Goldsworthy Extension Project Phase 2 - Yarrie project area, East Pilbara

BHP Iron Ore (Goldsworthy) Limited

**Report and recommendations
of the Environmental Protection Authority**

**Environmental Protection Authority
Perth, Western Australia
Bulletin 673
January 1993**

Figure 2: Diagram of ore body.

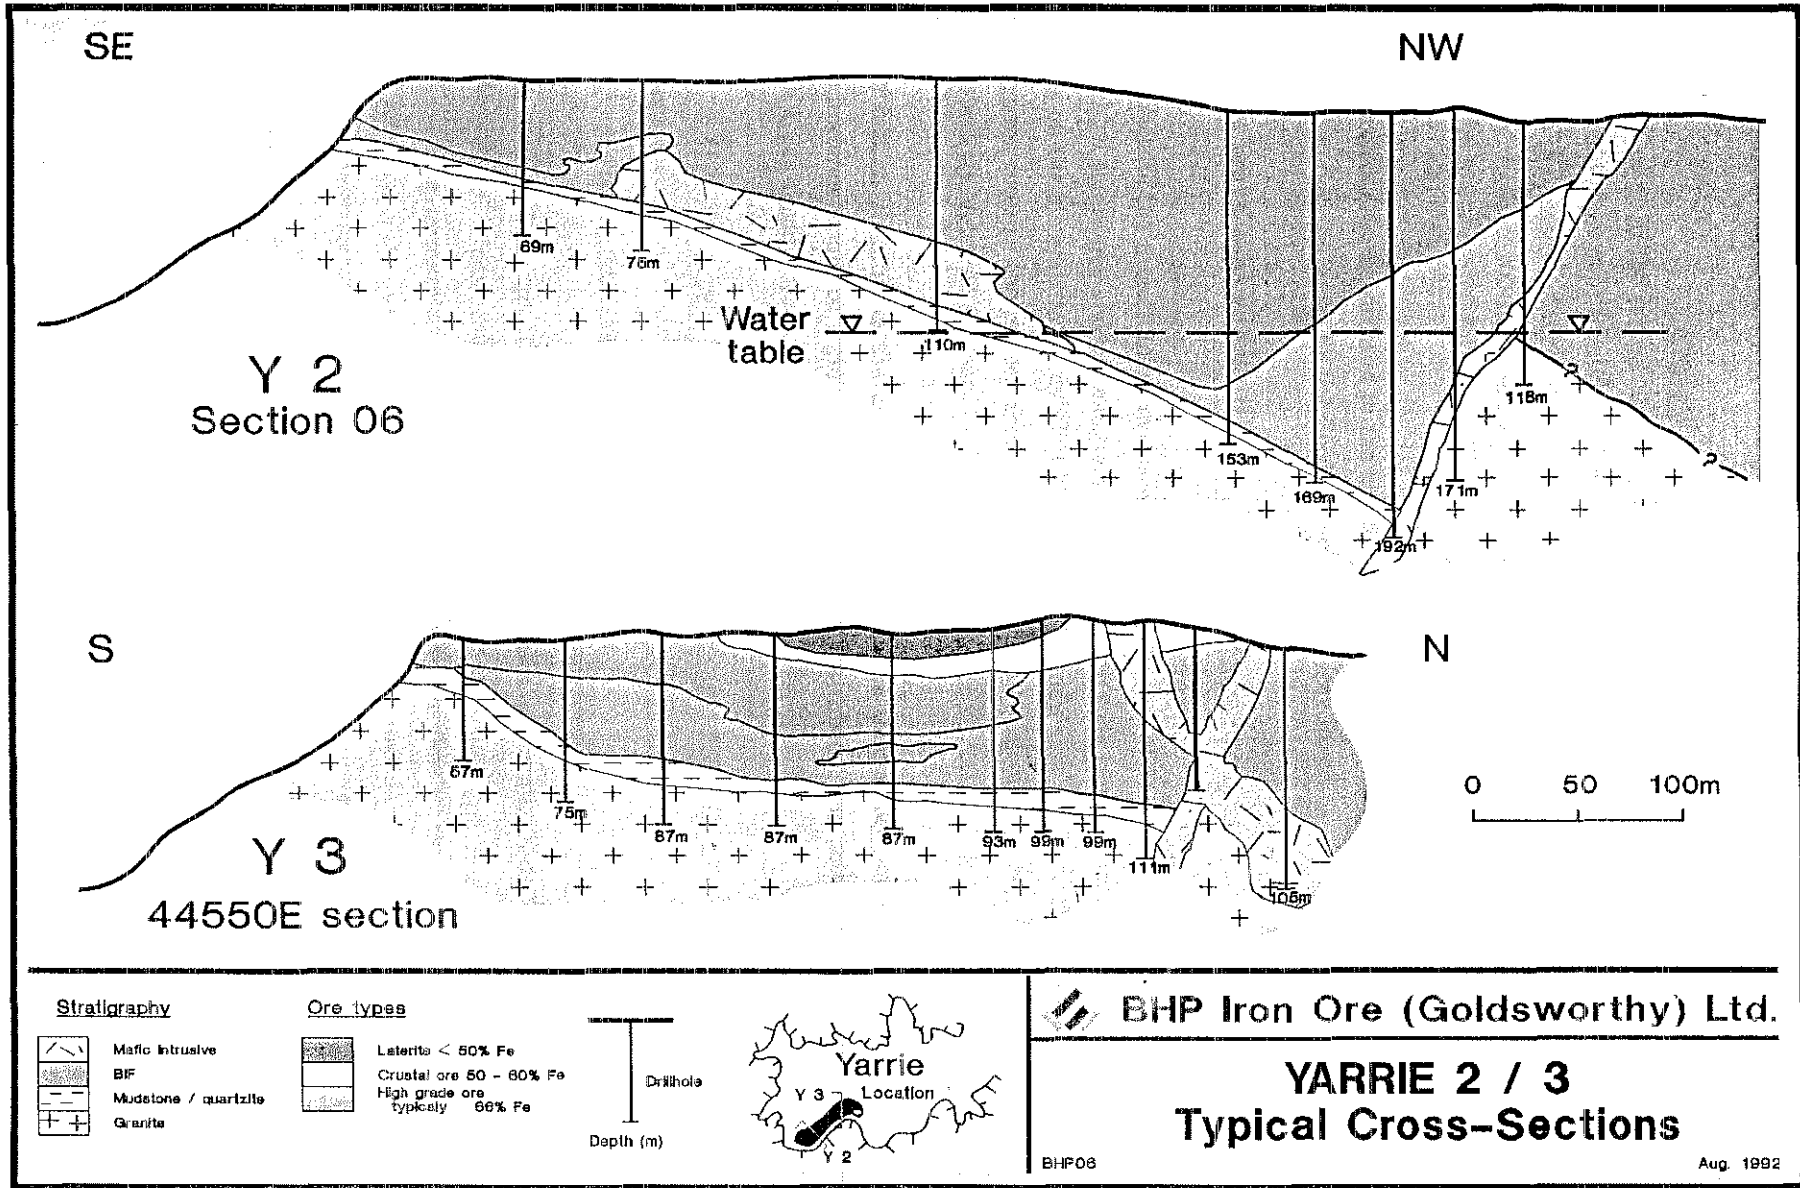
Submissions indicated that it would be preferable to backfill the Y2 pit to the original water table as part of rehabilitation. This would eliminate the perched water table being exposed to the atmosphere, thereby reducing evapoconcentration and removing the possibility of increased salinity of the water body. In order to fill the Y2 pit, 25 million tonnes of overburden would be needed and backfilling could not begin until the pit was mined out. If the pit was required to be backfilled the proponent stated that the project would be uneconomic as it would be very expensive to double-handle this quantity of overburden.

The CER did not provide sufficient analysis of the potential for salinisation of groundwater in the pit and saline water movement. The proponent acknowledged the need for further investigation and modelling of this issue and has undertaken further hydrogeological studies. The report is expected to be completed shortly. Due to the need for more data and consideration of contingency plans for surface and groundwater management, a water management programme should be developed prior to commencement of mining and updated as data becomes available and finalised at decommissioning.

It is preferable that the Y2 pit is backfilled to the original water table as part of rehabilitation. This would eliminate the perched water table being exposed to the atmosphere, reducing evaporation and removing the possibility of increased salinity in the water body. Based on information in the CER, it appears that by careful design of the mining plan, the cost of this rehabilitation could be minimised and the environmental impacts reduced. What is the justification for leaving the pit excavated below the water table? If backfilling to the water table doesn't occur, how will salinisation be managed?

To minimise the build-up of salinity in the decommissioned Y2 pit and the potential effects of such an increase on the water quality of the regional aquifer, the proponent stated the need and options for future management of salinity in the Y2 pit would be determined based upon monitoring results of the Mt Goldsworthy pit and results from ongoing hydrogeological studies. There needs to be a strategy or contingency plan in place prior to finalising the pit layout. This plan could then be upgraded as further monitoring data are collected and a decommissioning plan prepared soon after the cessation of mining.

- 2.1 The proponent should minimise the potential for salinisation in the Y2 pit and drawdown in order to minimise the potential groundwater impacts;**
- 2.1 The proponent should ensure that surface water discharge impacts and drainage shadow effects from the railway line are minimised;**
- 2.3 Prior to the commencement of productive mining, the proponent should design and implement a water management programme to the requirements of the Minister for the Environment on advice of the Water Authority of Western Australia and the Department of Minerals and Energy. This programme should be based on hydrogeological investigations and should include:**
 - surface water monitoring and management procedures;**
 - management of dewatering impacts; and**
 - long term management of any water bodies which expose the water table to long term evaporation.**
